Matter No. M10366

**In the Matter of an Application by Nova Scotia Power Incorporated
(NS Power) for approval of its Annual Capital Expenditure Plan
(ACE Plan) for 2022**

**EVIDENCE OF
JOHN D. WILSON
ON BEHALF OF
THE CONSUMER ADVOCATE**

FEBRUARY 24, 2022

1 **Figure 1: Actual Cost Compared to Approved Estimate, NS Power Completed**
 2 **Hydro Capital Projects 2012–2021**

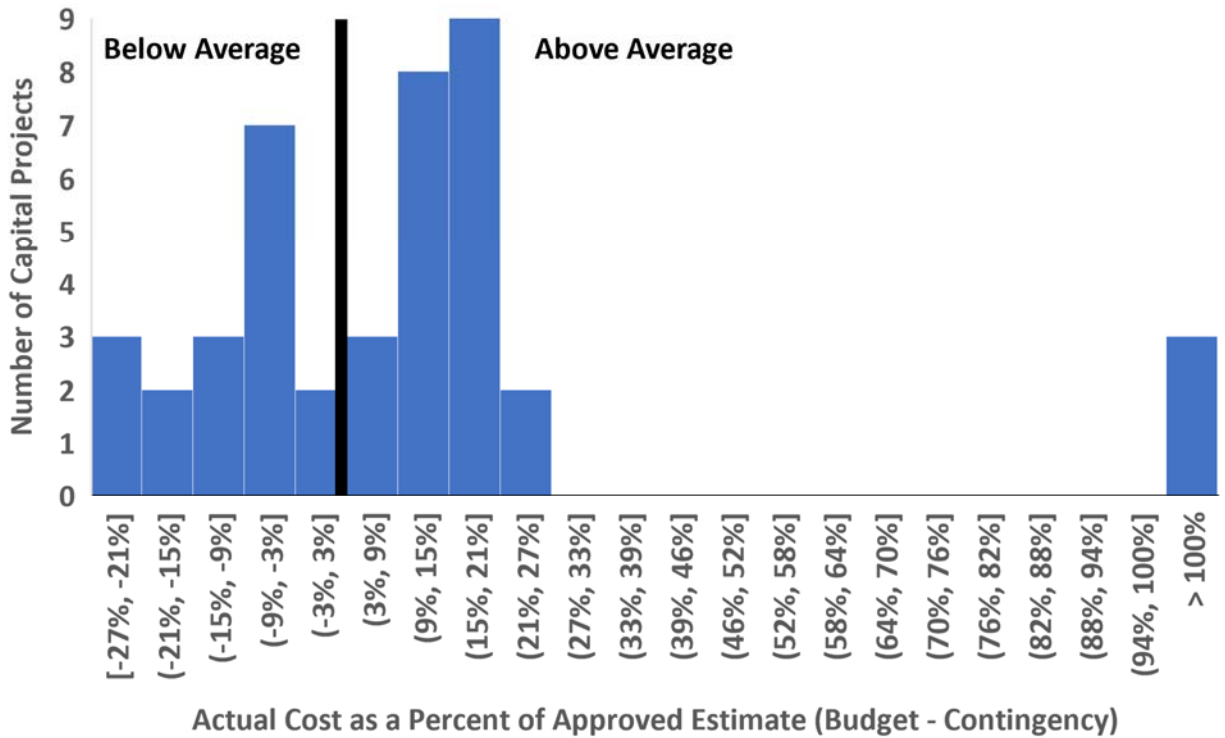
12 As illustrated in Figure 1, for all but the three outlier projects, the actual cost of projects
13 is distributed in a range from -27 to +26 percent of the cost estimate.⁵¹ This is roughly
14 consistent with the AACE International expected accuracy range for hydroelectric projects:
15 For Class 3 cost estimates, the typical variation in low and high ranges at an 80 percent
16 confidence level is -20 to +30 percent of the cost estimate.

17 AACE’s expected accuracy range suggests that a histogram of those variations should
18 be a roughly symmetrical curve, rather than one that is skewed heavily to the high-cost side.
19 Excluding the three high-overspend outlier projects, the main group of 39 projects averages
20 just 3 percent above the cost estimate. Thus, in spite of the skew, those 39 projects exhibit a
21 reasonably close correspondence to AACE’s expected variation in project costs.

11 As discussed in Section V.B (see Figure 1), the evidence indicates that for roughly 90
12 percent of its hydro capital projects, NS Power has completed work at costs that are
13 statistically consistent with its approved estimates. However, in the cases where those costs
14 vastly exceed the approved estimates, the Board has clearly put NS Power on notice that it
15 expects projects that are presented for approval to include project cost estimates based on
16 competent initial investigations, accurate project designs, and well-supported cost
17 estimates.

5 **Figure 2: Estimate Development Overview**

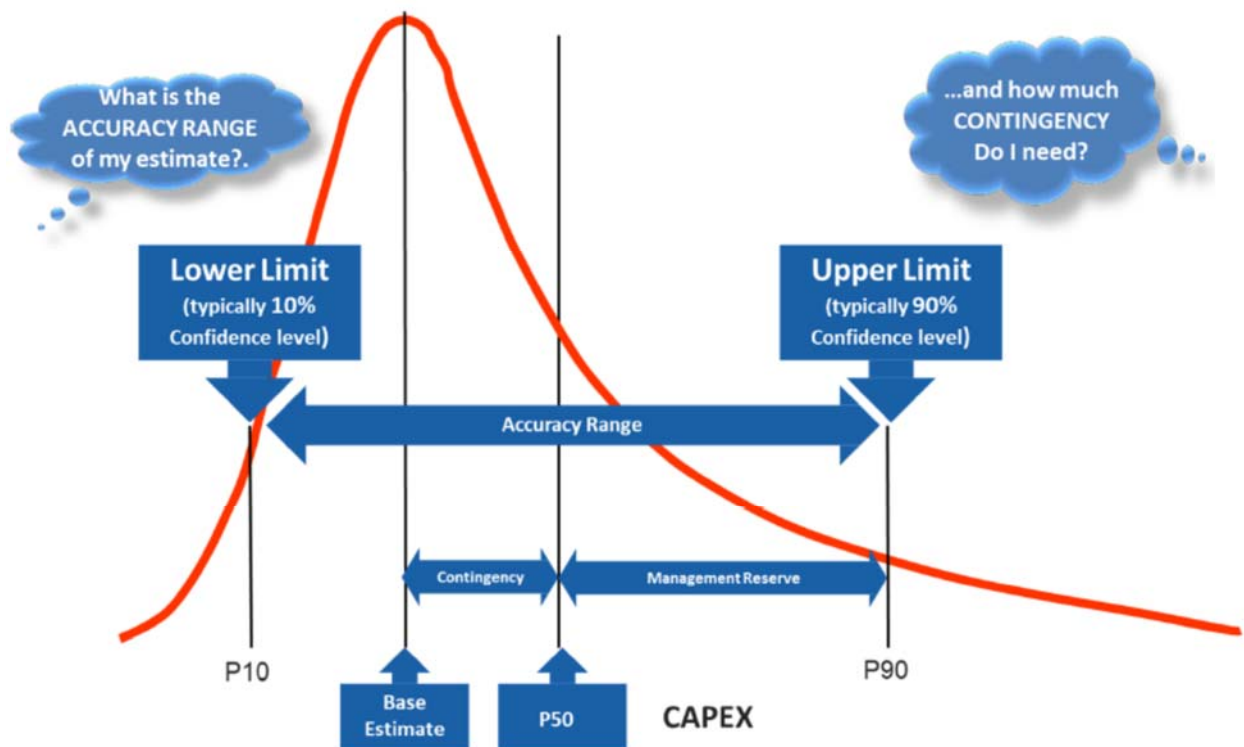
1 As shown in Figure 2 (labeled as Figure 1 in the Contingency Guidelines), the total
2 submitted cost estimate includes the base estimate plus the contingency, representing the
3 50/50 expected total cost. The variance can be expressed relative to either the submitted
4 cost estimate (including contingency) or the base estimate, depending on context.

27 While there is “no correlation,” the expected accuracy range plays a small role in
28 setting the contingency: As shown in Figure 2, the contingency should never be larger than
29 the expected accuracy range. Other than serving as an upper limit, the expected accuracy
30 range should not inform the selection of a contingency.

17 I recommend that the Board direct NS Power to clarify the Contingency Guidelines to
18 avoid relying on the expected accuracy range to set the contingency, and to consider the
19 approach I have suggested above for application of the predetermined guidelines method,
20 with further application of documented subject matter expert judgement.
